**Re: Response to Review Comments, Hydrogeology Consultant Services Inc. & NVCA, 537090 Main Street, Horning's Mills**  
**Cambium Reference: 17217-001**

Hydrogeology Consultant Services Inc (HCS) has the provided review comments on behalf of the Corporation of the Township of Melancthon, dated March 3, 2025, regarding Cambium's Hydrogeological Assessment report prepared for your proposed subdivision development located at 537090 Main Street, Horning's Mills, Township of Melancthon, Ontario (Figure 1; Figure 2; Site). Additionally, Nottawasaga Valley Conservation Authority (NVCA) has provided review comments on behalf of the Province of Ontario under authority of O.Reg. 41/24, dated May 28, 2025. The objective of this letter is to provide a summary and Cambium's responses to the HCS and NVCA comments.

**Table 1: Test Well Construction Details**

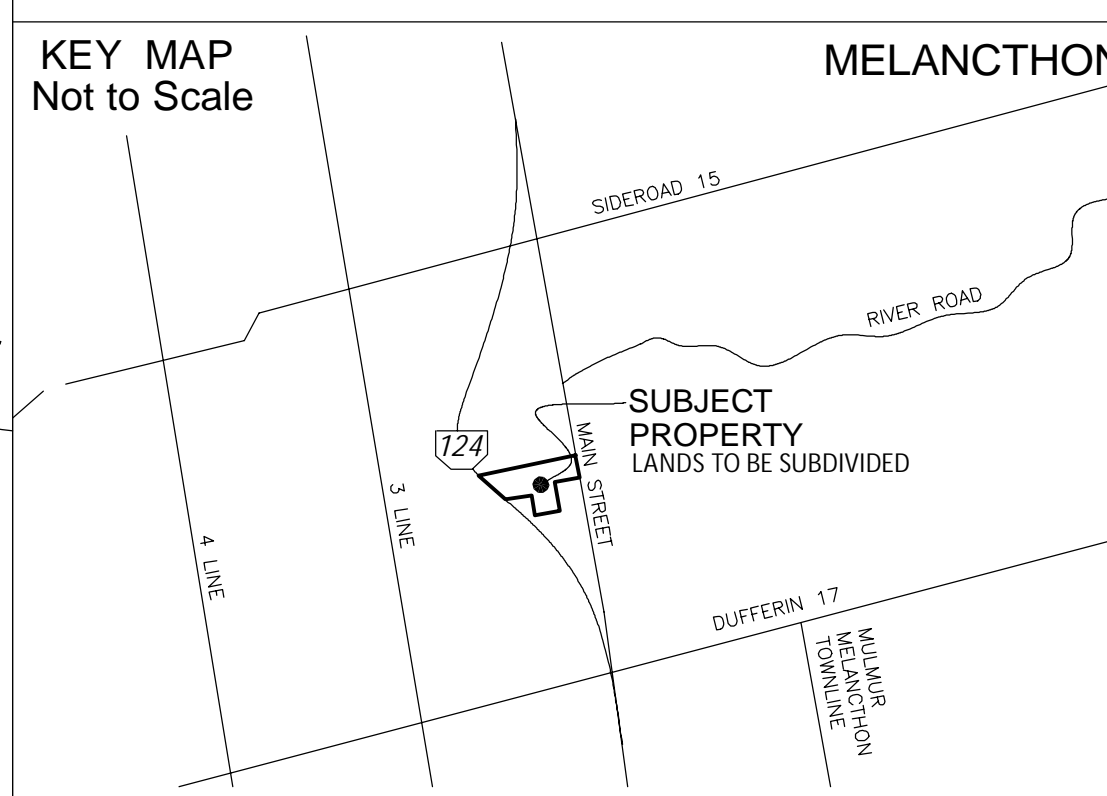
*HCS comment #2:*

*“Assessment of the potential reason(s) for the significant difference in well performance and well capacity of TW103-24, and the potential impacts of multiple water supply wells servicing the proposed lots having similar performance and well capacity.”*

Test well’s logs and Lidar elevation data were used to compile the test well construction details in Table 1 attached. As provided in Table 1, test well TW103-24 was drilled to a more shallow depth at 20.0 mbgs compared to TW101-24 and TW102-24 at 24.4 and 29.9 mbgs, respectively. All the wells were advanced into limestone bedrock however. While TW103-24 has encountered only one water bearing fracture at a shallower depth of 15.8 mbgs (451.9 masl), the other two test wells encountered water bearing fractures at deeper depths. In test well TW101-24, water bearing fractures were identified at 19.8 mbgs (457.7 masl) and 21.6 mbgs (455.8 masl). While in test well TW101-24, water bearing fractures were identified at 19.8 mbgs (457.7 masl) and 21.6 mbgs (455.8 masl). Considering TW101-24 and TW102-24 have two deeper fractures contributing to water supply, it is inferred that this is the reason for the lower yield at TW103-24. TW103-24 was still able to perform at minimum pumping rate of 15 L/min which is within the >13.7 L/min threshold of Procedure D-5-5. If other future wells drilled

for the proposed lots have a similar performance to TW103-24, they will still adhere to the capacity requirement of Procedure D-5-5.

The static water level prior to the May 9, 2024 pumping test in TW103-24 was 8.64 mbtop. The pump was installed at a depth of approximately 20 mbtop. The available drawdown in the well was therefore approximately 10.4 m (height of static water level above the pump). The water level at the end of the 6 hours of continuous pumping was 16.72 mbgs meaning that the well still had about 3.3 m of available drawdown. In Cambium's professional opinion, the residential wells will not be pumped for 6 hours continuously in typical daily usage and that there would be sufficient available drawdown for other wells that have similar performance as TW103-24.
